Elevation QC Report

OR_GrandeRondeBasin_2009 **Watershed Sciences Project: Contractor:** 07/05/2011-07/07/2011 04/20/2011 **Data Delivery Date: Date Data Reviewed:** Jeremiah Vinyard-Houx 643.26 **Total Square Miles Reviewed: Reviewer:** Tile size: 3 75 Ouads 3 int. feet **Grid Spacing: Elevation Type: LIDAR Format: .img**

Figure 1: Project Area, note highlighted projects are the only ones for which data was received for this project.

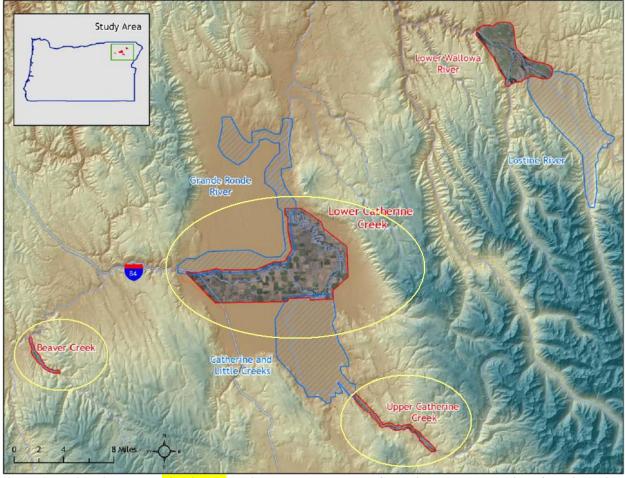
From the original project the Beaver Creek, Lower Catherine, and Upper Catherine datasets were donated to the USGS, see figure 1.

Figure 4: Example of waterbody not leveled.

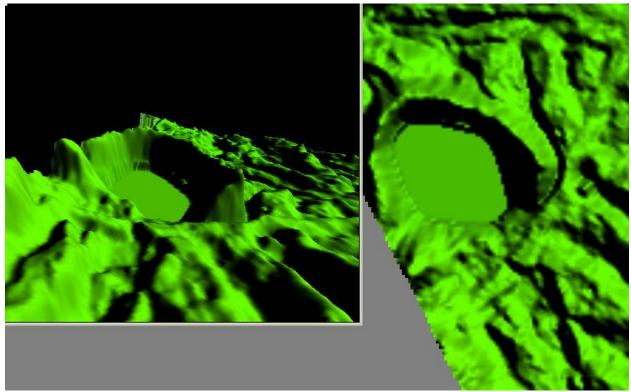
Issues with this project's bare earth rasters include no hydro conditioning/breakline enforcement of stream features, several waterbodies not leveled (largely oxbow lakes and chiefly in the lower catherine portion of the dataset, and one bridge not removed. Waterbodies and the bridge were leveled for the final bare earth raster.
